# Construction Traffic Management Plan – Pitt Street South Site – Demolition Works Amendment 1

Project: Sydney Metro City & Southwest – TSE Works

Document No: SMCSWTSE-JCG-SPS-TM-PLN-002288

**RE: Endorsement of Construction Traffic Management Plan – Pitt Street South Site - Demolition Works Amendment 1: Sydney Metro City & Southwest – TSE Works**

Figure 3 Kerbside use changes

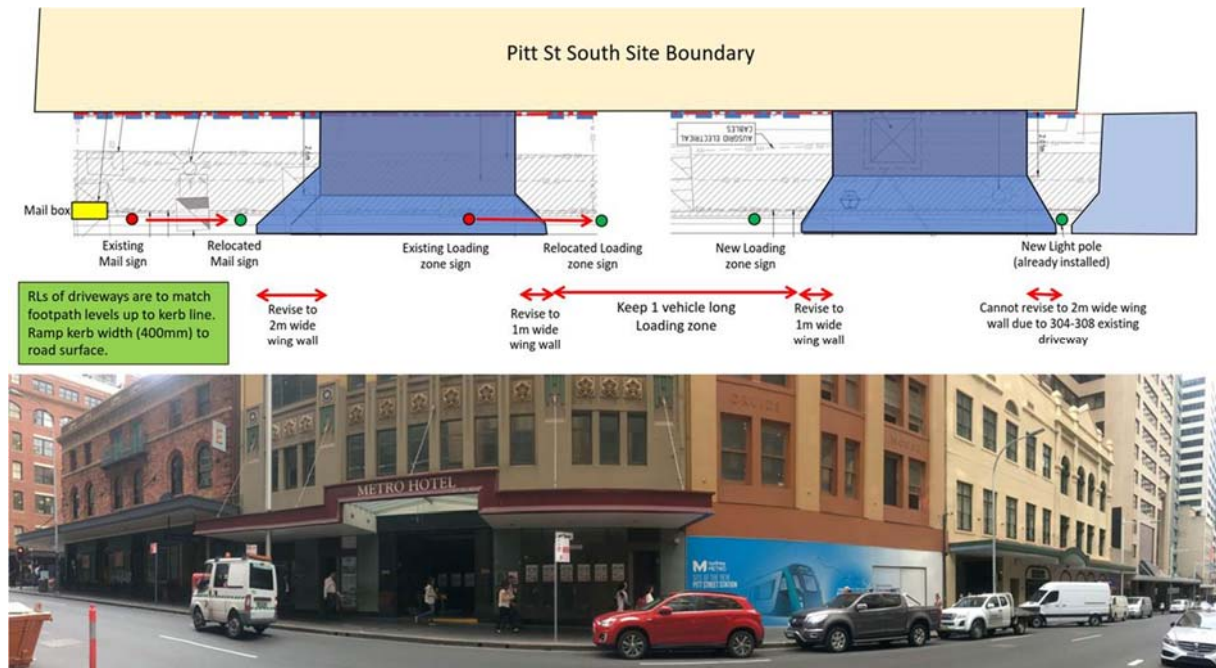
5	TSE	JHCPBG JV	D		SCO	<p>At the on-site meeting it was discussed that some parking changes would be required to facilitate construction of the northern driveway.</p> <p>Please include some detail on the parking changes required and the associated impact.</p> <p>Please also advise if there a need to take these changes to local traffic committee for approval.</p>	Document amended
6	TSE	JHCPBG JV	D	3.2.1	SCO	<p>Details on traffic flow has been provided post the arrival of machinery, but what is the impact during the arrival of machinery?</p>	The CTMP states: "Machinery deliveries will be undertaken outside of site operating hours, where the machinery is unable to be delivered to site via the nominated vehicular crossing."
7	TSE	JHCPBG JV	D		SCO	<p>What is the expected impact on traffic flow during the crane works?</p>	Document amended
8	TSE	JHCPBG JV	D	3.2.3	SCO	<p>Please consider including a sentence on the pedestrian management in place during vehicle access and egress.</p>	Document amended

SYDNEY METRO CITY & SOUTHWEST	
PITT STREET STATION AND PRECINCT	
TRAFFIC MANAGEMENT	
PITT STREET ACCESS	
SU12.5-SWEPT PATH PLAN	
FILE No.	SHEET: 10F 1
STATUS:	
DRG No. JCG-SPS-TM-DRG-002284-0051	EDMS No. A2

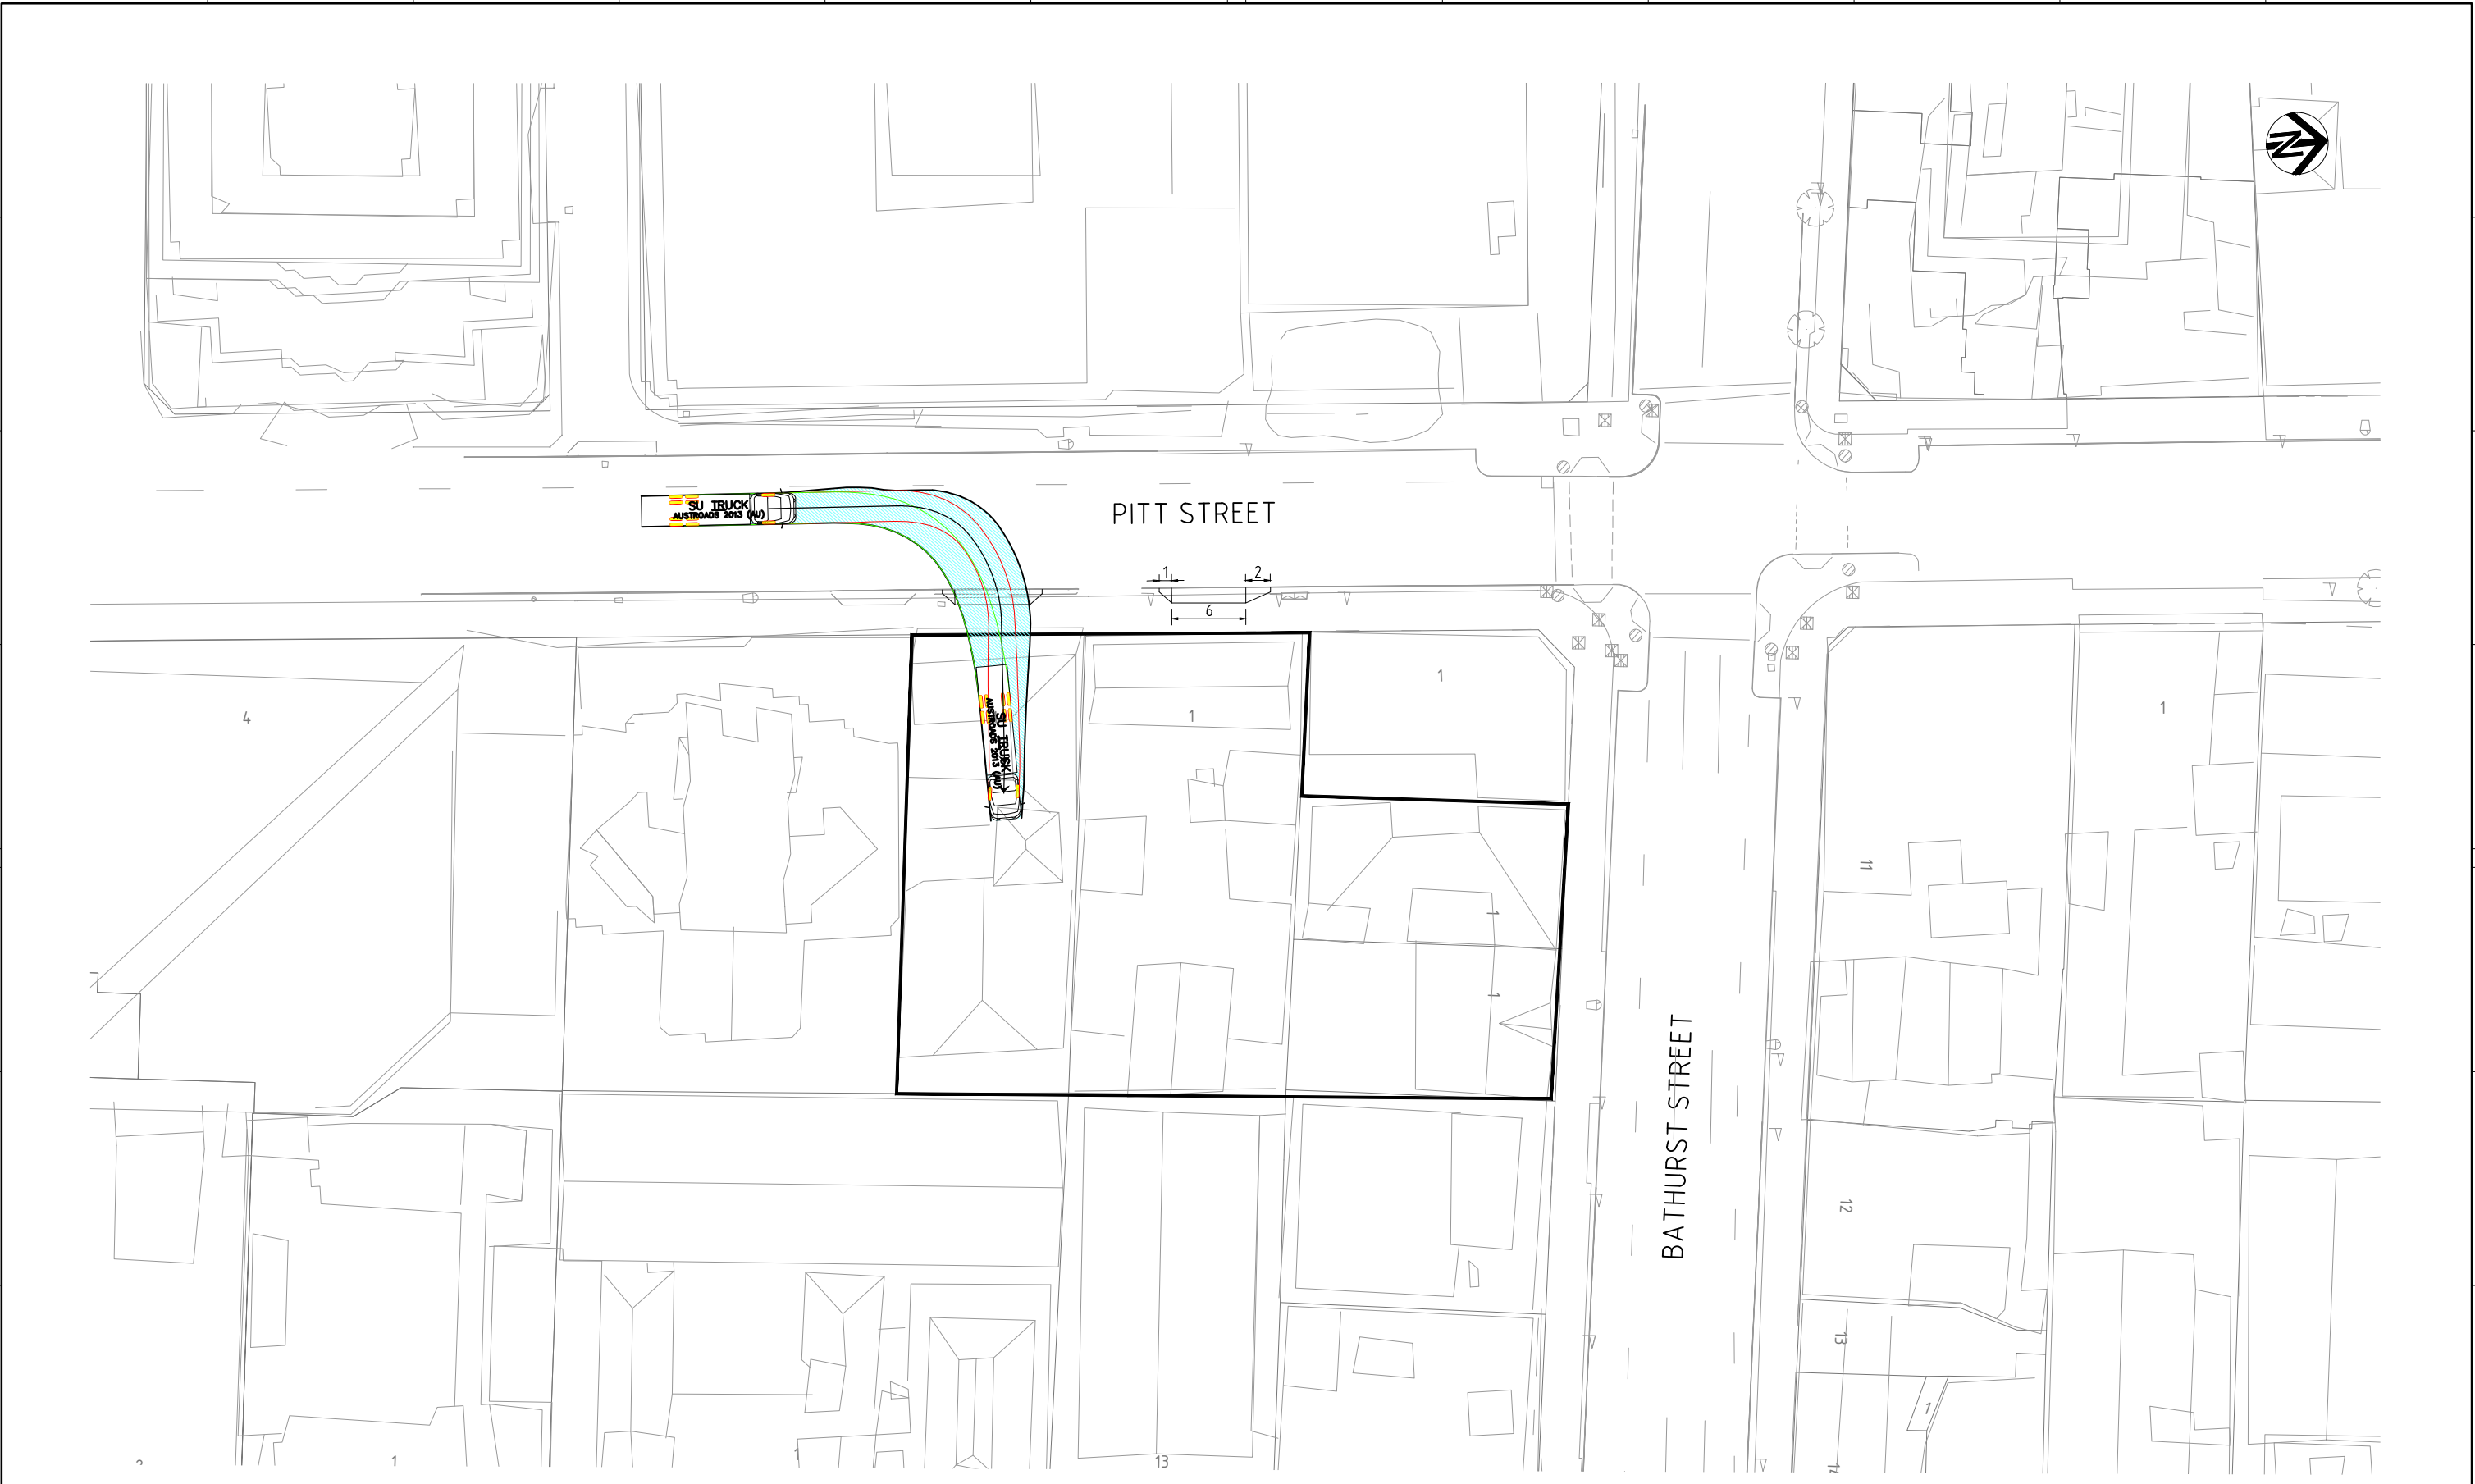
17	TSE	JHCPBG JV	D	DRG-002284-0051	SCO		Has a swept path analysis been conducted to confirm whether vehicles can turn around within site to enter/exit in a forward motion? Please investigate and provide turning paths in revised CTMP.	refer to response to Item 4
18	TSE	JHCPBG JV	D	DRG-002284-0052	SCO		Has a swept path analysis been conducted to confirm whether vehicles can turn around within site to enter/exit in a forward motion? Please investigate and provide turning paths in revised CTMP.	refer to response to Item 4
19	TSE	JHCPBG JV	D	TCP-SPS-PIT-NB-3401	SCO		A 15m merge taper appears to be a relatively short distance. Please ensure it is in accordance with TCAWS.	Drawing amended
20	TSE	JHCPBG JV	D		SCO		Service vehicles using Wilmot St may find it difficult to make the turn into / out of the street. Can you advise how this will be managed?	Drawing amended
21	TSE	JHCPBG JV	D		SCO		The cones to the north of the site (near Bathurst St) extend past the work area. Are they able to be pulled back to allow greater storage at the intersection?	Drawing amended
